Roswell Road - Mixed Use Community
A Master Planned Residential & Assisted Living Community

REZONING
SITE PLAN

PETITION NO: Z-51

ZONING COMMENTS:

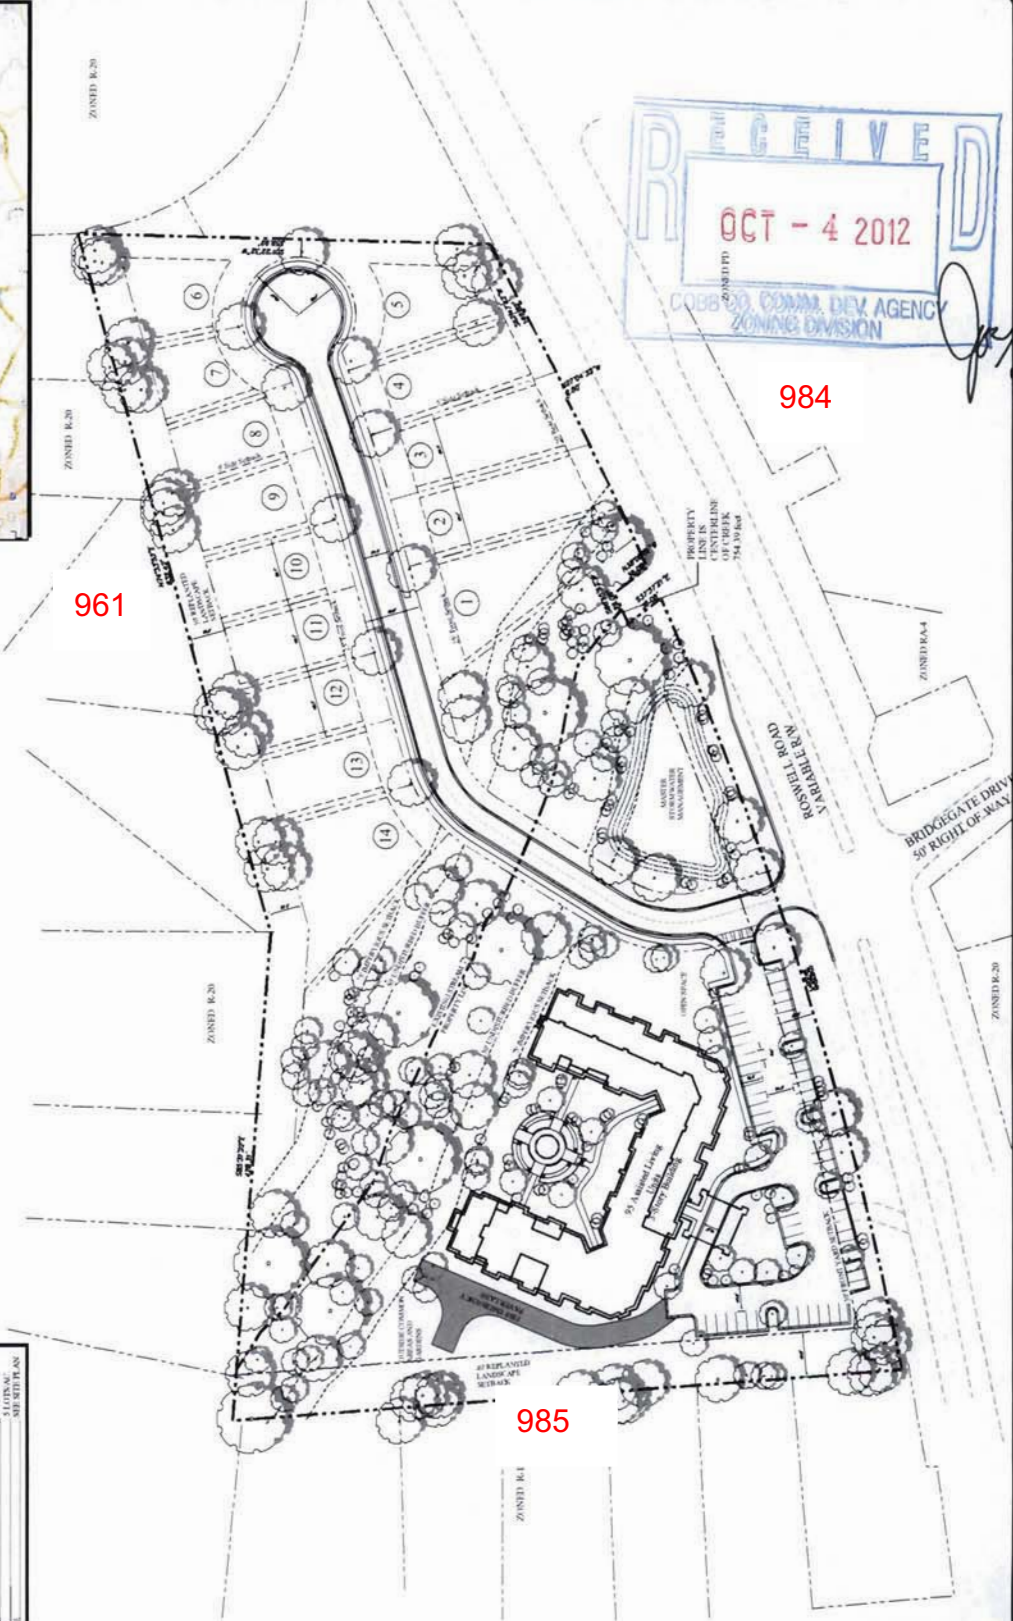
The proposed site plan will need the following contemporaneous variances:

1. Waive the rear setback on the RA-5 lots abutting Roswell Road from the required 40 feet to 20 feet;
2. Waive the rear setback on the RA-5 lots on the northern property line from the required 40 feet to 30 feet; and
3. Waive the minimum lot width for the RA-5 lots from the required 75 feet to 60 feet.

ACCESS: Fire apparatus access roads shall extend to within 150 feet of all portions of the facility or any portion of the exterior wall of the first floor (State Modifications IFC 503.1 2006 Edition). As proposed fire apparatus access is not provided according to the standard and a full NFPA 13 Fire Sprinkler System will be required.

Recommend curb, gutter, and sidewalk along Roswell Road frontage.

Recommend curb and gutter along both sides and sidewalk along one side of proposed development roadway.

Recommend a deceleration lane on Roswell Road for the entrance.
